**1 Products affected**

Product hierarchy no. *			Part no.	SBU	Type / Description	Customer part no.	
SBU / PG	PGU	Type					
02	007	038	0000002296	4796.0000	Connector	4796 Cord connector	
02	007	038	0000002365	4310.0008	Connector	0106 Cord connector	
02	007	038	0000002365	4310.0009	Connector	0106 Cord connector

**2 Type of change**

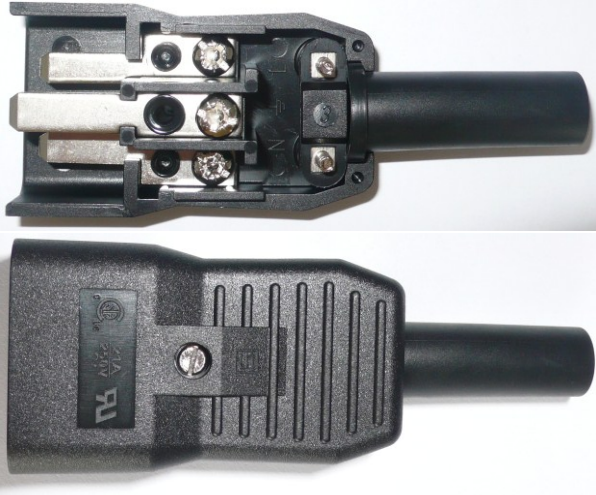
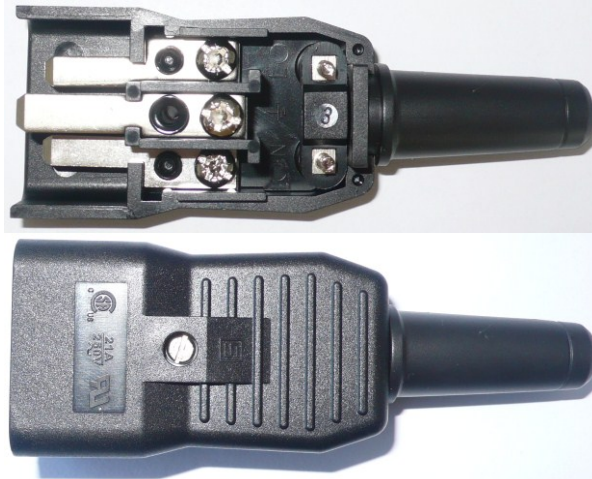
A new tool has been made.  
Modification of the Approval marks.  
With the production of the new tool the opening for the cable guard has changed too.

The flange of the cable guard was round, what caused an insufficient hold of the cable guard.

NEW the flange of the cable guard is square, what improves the holding of the cable guard.

To pass the stronger test requirements according to IEC 60320-1 (Sect. 22: Cords and their connection), flange and slot on the cable guard had to be reinforced. As there have been made new tools for the moulding parts the holding of the cable guard got improved with a round opening.
